## **OAK HILL SUBDIVISION**

APPLICATION NUMBER 7 DATE June 15, 2006

REQUEST Subdivision

# DETAIL SITE PLAN

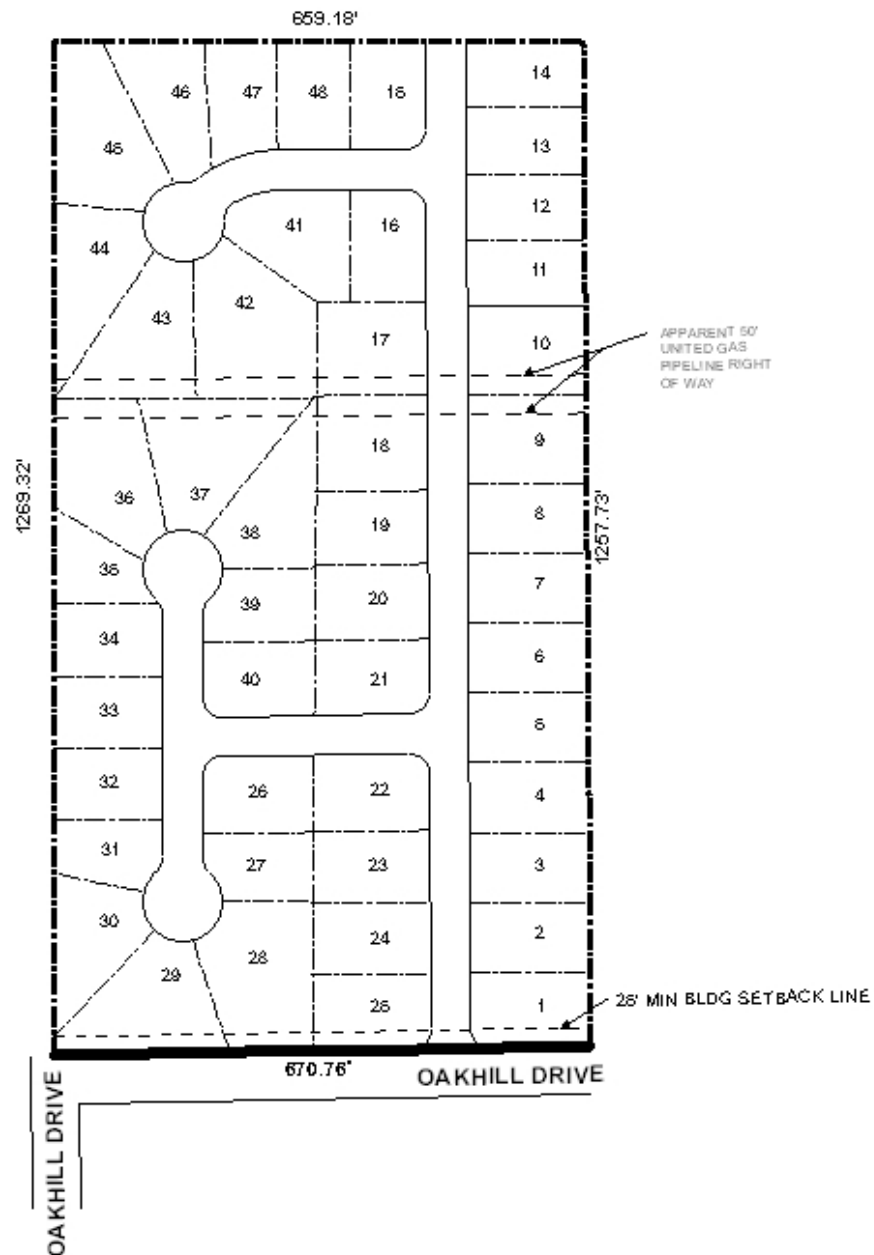
The site fronts Oak Hill Drive, with a 60-foot right-of-way; and adjoins (along the Western boundary) the future right-of-way of Magee Road, a planned major street requiring a 100-foot right-of-way. As such, dedication should be required to provide 50 feet from the centerline of the planned major street. It appears that the centerline of Magee Road may fall on (or very near) the Western boundary, in which case the proposed lots could be reduced by nearly half, and may not meet the minimum lot size requirements. The applicant should ensure that the design will provide for adequate area for all lots after dedication. In addition, as a means of access management, all lots should be denied direct access both to Oak Hill Drive and Magee Road.

The proposed subdivision also involves the creation of new streets, which must be constructed and dedicated to County Engineering standards prior to signing the final plat. One street is over 1200 feet long and very straight, and would therefore require calming devices; the only kind of calming device that the County will accept is a traffic circle. Based on its length, it is recommended that this street feature two traffic circles. Intersections might be suitable locations; however, size, location, and design will be subject to County Engineering approval.

Traffic circles should be shown on the final plat as common area. While detention is not shown on the final plat, if it is required, the space should be shown as “common detention area” on the final plat. A note should be required on the final plat stating that maintenance of all common areas is the property owners’ responsibility.

The 25-foot building setbacks are noted but not drawn; these should be drawn on the final plat.

Based on the preceding, it is recommended this application be held over to the July 20<sup>th</sup> meeting, to allow the applicant to revise drawings to show the planned major street dedication; adequate area for all lots; and traffic calming devices. Revised materials should be received in Urban Development by June 26<sup>th</sup>.
